Dolby Laboratories Inc

Field Bulletin 219

Models CP500 and DA20

Intermittent Cat. No. 671 Failure

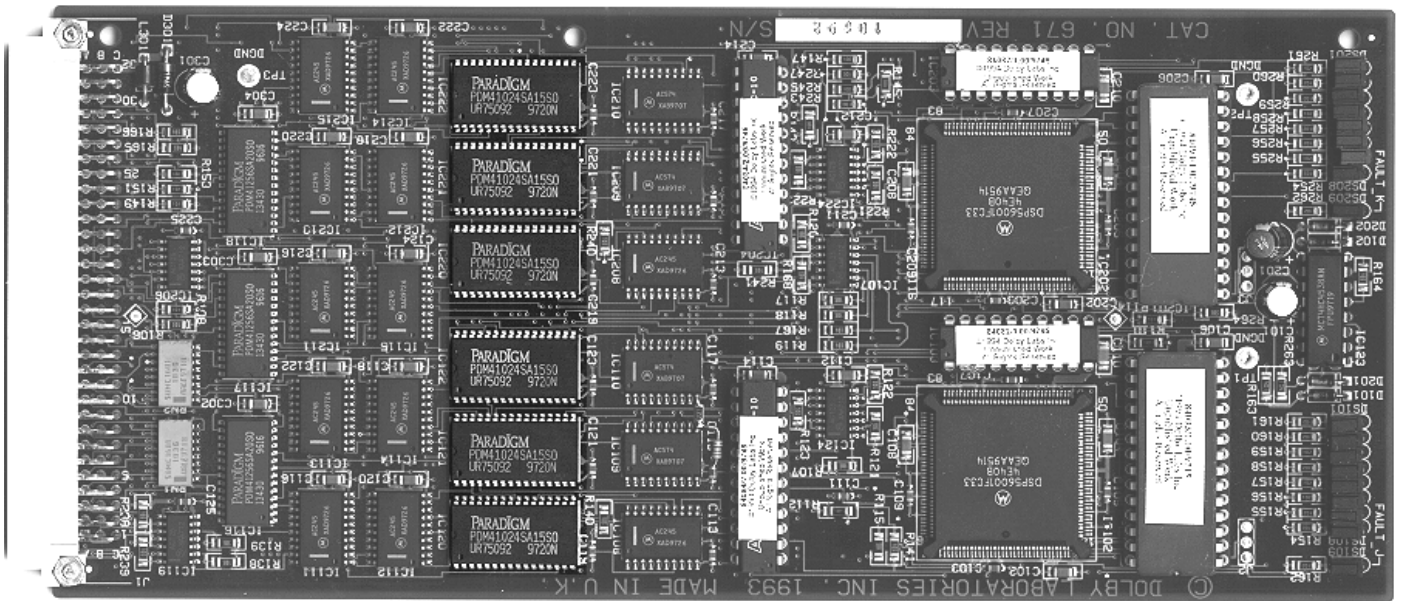
Any Cat. No. 671 board which shows this specific problem and which uses SRAM parts manufactured by PARADIGM with batch code UR75092 and date code 9720N in any of the six locations IC120, IC121, IC122, IC220, IC221 or IC222 should be returned to Dolby Laboratories for replacement.
